SERVICE BULLETIN No. 319 26 4099

Subject:
Fire detection - Fire detection assembly.
Modification TF 99.

APPLICABLE ENGINE / VARIANT(S)	EFFECTIVITY CODE	MAINTENANCE LEVEL	CONDITION OF APPLICATION	EFFECT ON OPERATION
ARRIUS 2 F	2-A-1	1, 2, 3	Application if the fire detector is replaced	Removal/installation of the fire detection assembly
		4	Application upon first return to an approved Repair Center, if the repair gives access, at least, to one of the fire detectors

Figure 1

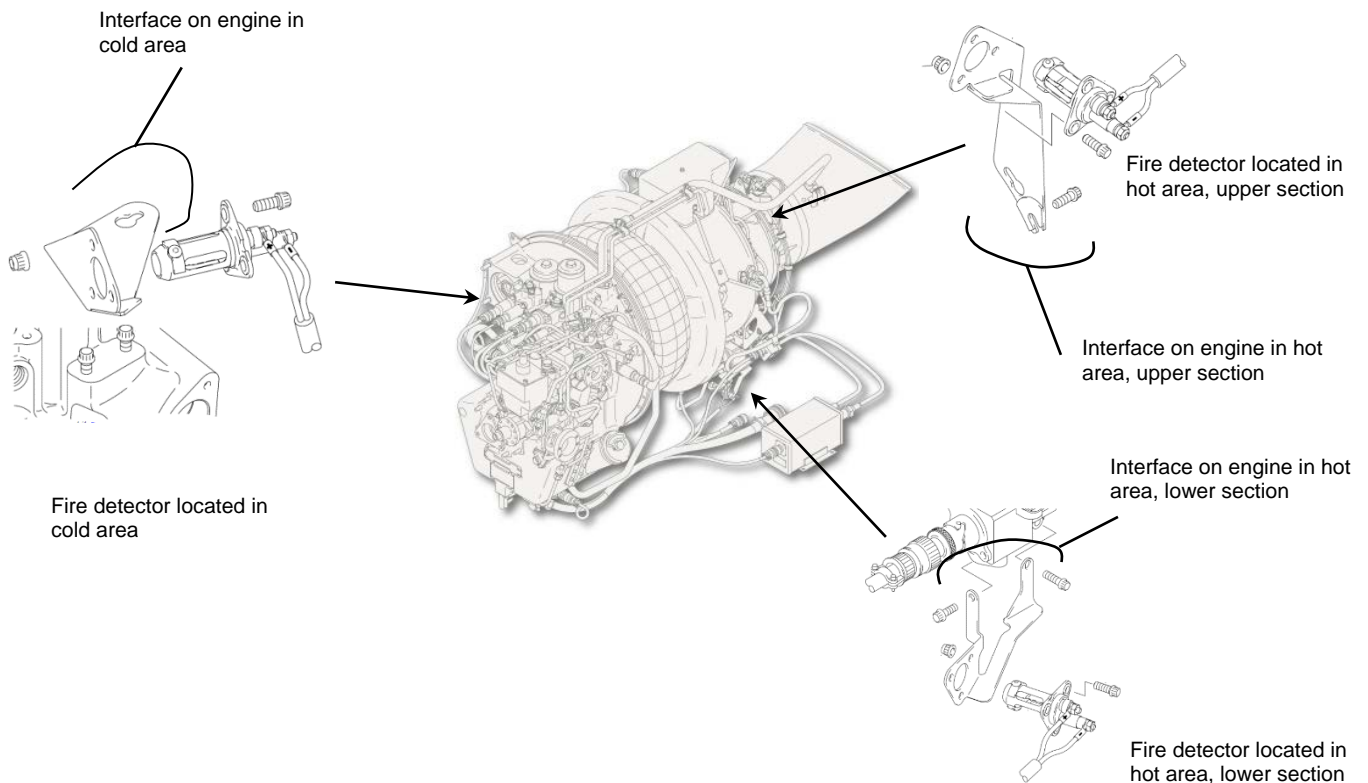
1.1.2. Analysis (Figure 1)

Fire detectors are attached with a screw-nut assembly to supports that are different between the cold area (front part of the engine) and the hot area (rear part of the engine, upper section and lower section) in their shape and their securing interface on the engine (Figure 1). These supports are not interchangeable on the engine.

Figure 2

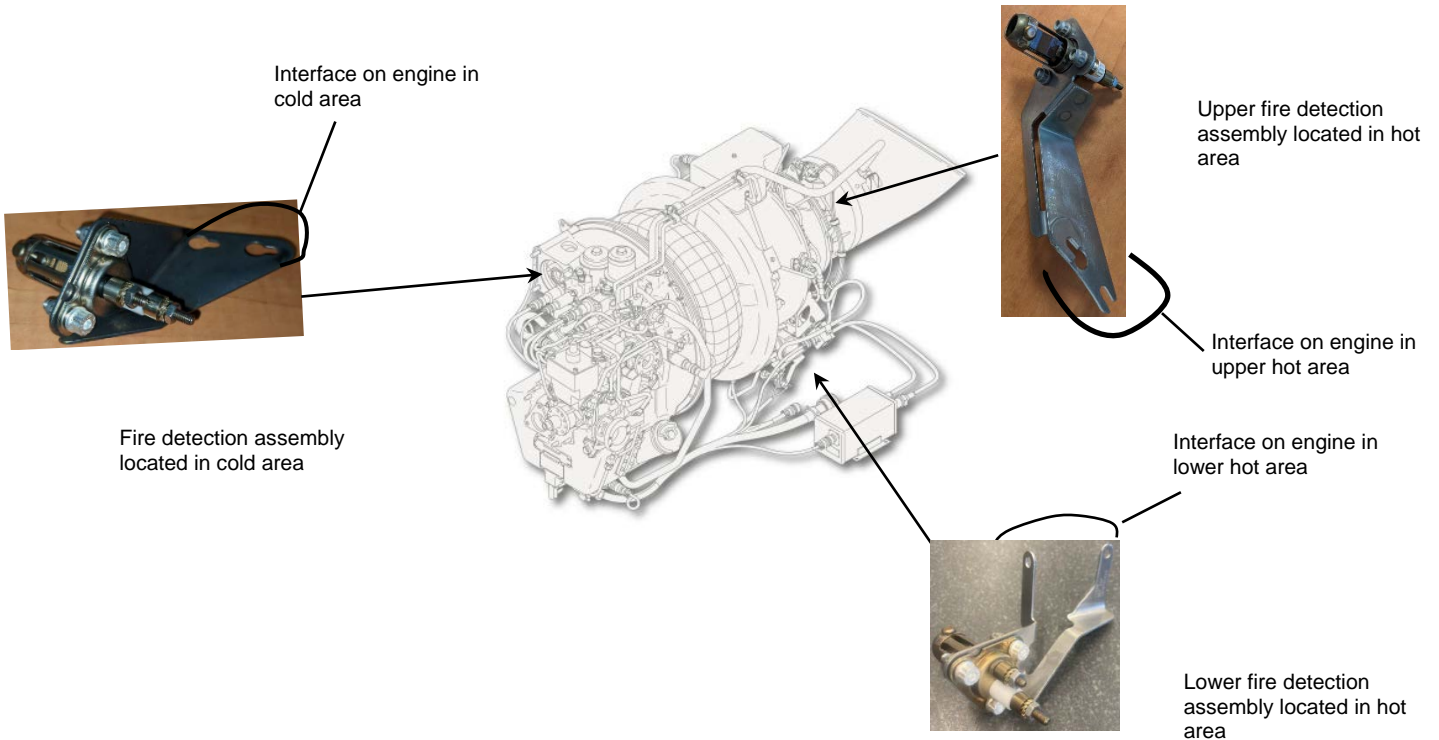
1.1.3. Solution (Figure 2)

Safran Helicopter Engines developed TF 99 modification that creates an inseparable fire detection assembly that includes the detector and its support, for each of the three locations (cold area and upper and lower hot area). These three POST TF 99 fire detection assemblies have an interface on engine that is different and thus they are no longer interchangeable by mistake (Figure 2)
